5.1. MATERIAL CHANGE OF USE- FUNCTION FACILITY ESCAPE STREET PORT DOUGLAS

REPORT AUTHOR(S)	Daniel Lamond, Planning Officer
GENERAL MANAGER	Michael Kriedemann, Acting General Manager Operations
DEPARTMENT	Development Assessment and Coordination
PROPOSAL	Material Change of Use (Function Facility)
APPLICANT	Port Douglas Steam Train Company Pty Ltd c/- RPS Australia East Pty Ltd PO Box 1949 Cairns QLD 4870
LOCATION OF SITE	9 St Crispins Avenue PORT DOUGLAS and 4-6 Escape Street PORT DOUGLAS
PROPERTY	Lot 49 and 51 on SP161464

Drawing or Document	Reference	Date
Function Facility Site Plan	Drawing Number PR133458-5, prepared by RPS Australia East Pty Ltd	14 June 2018

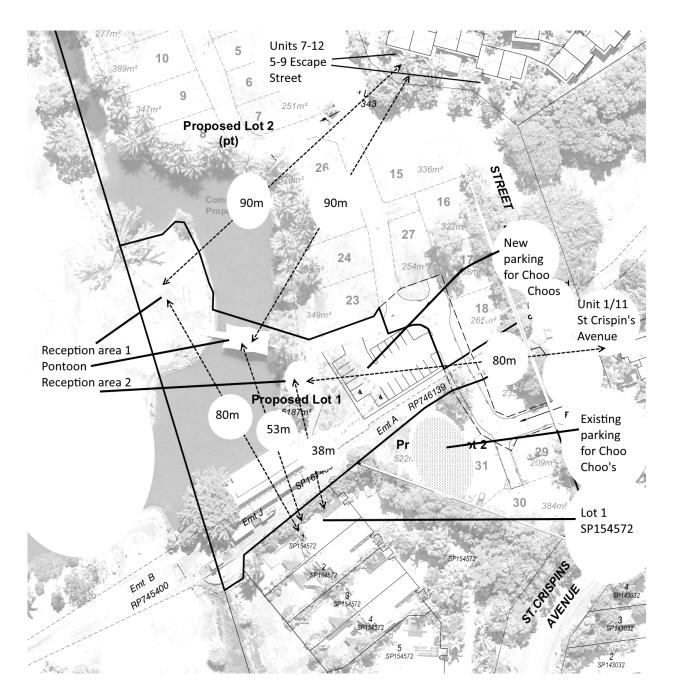
Figure 1 shows a plan of the venue and the adjoining residences. The existing venue consists of a restaurant with seating on the Northern side of the building. A pontoon is moored approximately 25m North of the station building. The application before the Shire Council entails the use of this pontoon and the grounds adjacent (East) to it for functions, like weddings.

Figure 1 also shows the nearest residence at unit 1/11-17 St Crispin's Avenue, which sits on Lot 1 on SP154572.

The nearest distance between the proposed wedding facilities pontoon and Lot 1 on SP154572 is 53m. The distance from the reception area to Lot 1 on SP154572 is 38m.

Compared to the measured distance of 3m this means an attenuation of respectively 25dB and 22dB. Distance attenuation follows the rule of 6dB attenuation for each doubling of distance, 20log (D1/D2).

A 6m high steel fence was recently placed in front of Lot 1. According to Vicroads publication 'A guide to reducing traffic noise' fences can reduce the noise by 5 - 10dB. For this case a prudent 5dB has been chosen.
